## **STAFF RECOMMENDATION**

**CASE FILE NO.:** Z0506-18-D

**PROPOSAL:** Design review of proposed development of approximately 12.64 acres of currently undeveloped land in the Clackamas Industrial Area. The site is currently vacant. Applicant is proposing to construct a tilt-up concrete building of approximately 123,143 square feet to be used as a processing facility for the recycling of beverage containers with accessory office space. Additional site improvements are to include grading, extension of utility service, new site access from 120<sup>th</sup> Ave, new site circulation, parking for semi-trailer trucks and private vehicles, landscaping, and security fencing.

# Site Plan

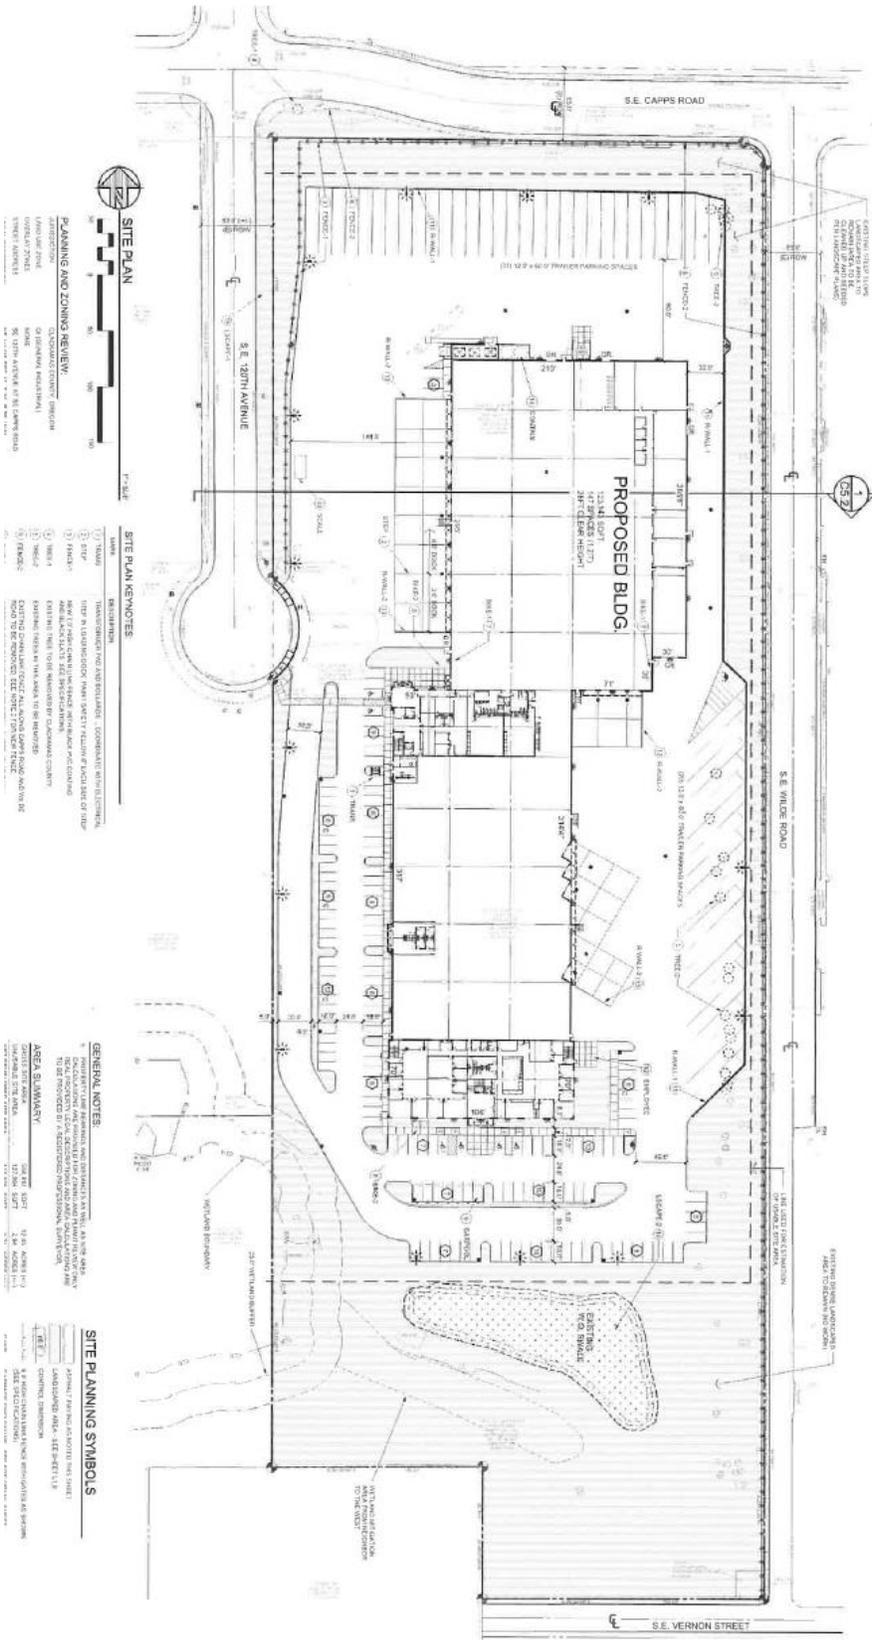
**Finding:** The following findings are based on staff’s review of the applicants submitted site drawings. The site plan includes a new sidewalk from the end of the cul-de-sac (public sidewalk) that runs adjacent to the driveway to the main entry of the building. There is only one building and interconnected walkways are not applicable. The site will include new site lighting to meet code from the street to the building. All new sidewalks on the site are concrete and at least 5-foot wide. The main entry sidewalk does not cross driveways but does bridge between parking areas. It runs adjacent to the car drive aisle and is raised 6-inches above the grade. The distance between the main entry and the public street exceeds 75-feet. The sidewalk between the two is located adjacent to the car drive aisle and includes a landscape strip with trees. This project does not include striped crossing paths. The sidewalk adjacent to the parking are 7-foot wide. This project has only one building and does not require interconnected walkways. These criteria are met.

**Finding:** All parking areas are accessible and drive aisles include required maneuvering areas, the parking stalls indicated in the site plan meet the dimensional requirements of the ZDO. 15% of the auto stalls on site are 8.5'x16'. The minimum dimensional standards for the type of parking selected have been met. The parking lot uses almost exclusively double loaded 90-degree parking. The appropriate number of car/vanpool spots are indicated. The auto parking lots are less than one acre. This site is designed to separate auto and truck traffic and thus a shared driveway is not feasible. The parking lot curb provide an appropriate stop for vehicles. The area in front of vehicles is either concrete sidewalk or ground cover landscaping. These criteria are met.

**Finding:** The required minimum parking for this development is 127 spaces based on the square footage of the building and the count requirements as shown in Table 1015-1. The current site plan shows 147 spaces. The criterion is met.

# Building Elevations

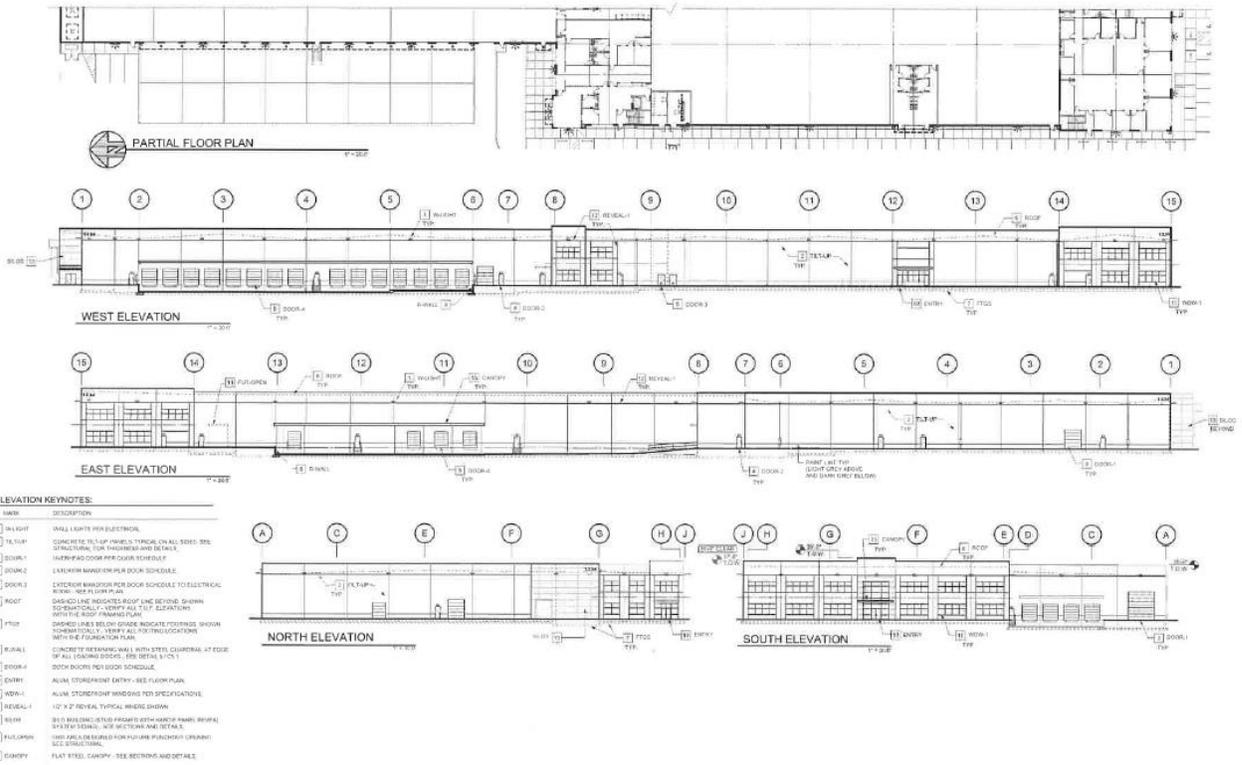
**Finding:** The building provided the modulation of the façade plane (in/out) as well as the parapet line (up/down) creating architectural relief and creating architectural features consistent with the use of the building. Paint scheme allows for complementary shading and differentiation of spaces and uses, creating visual interest. The design of the façade appropriately reflects the proposed use of the interior space, with public entrances and office spaces having a higher level of detailing and articulation and the warehouse/processing spaces remaining a more utilitarian design. These standards are met.

**Finding:** The proposed building has a flat roof which will not have visible surfaces. It is surrounded with a concrete parapet. The cap flashing will be painted a contrasting color to provide visual interest. The criteria are met.

**Finding:** This building is a concrete tilt-up building on all sides, which is both durable and consistent with the visual identity of other development in the Clackamas Industrial Area. The project team has added metal siding and steel canopies to the main entries and will provide paint accents and reveals to all aides of the building. These criteria are met.
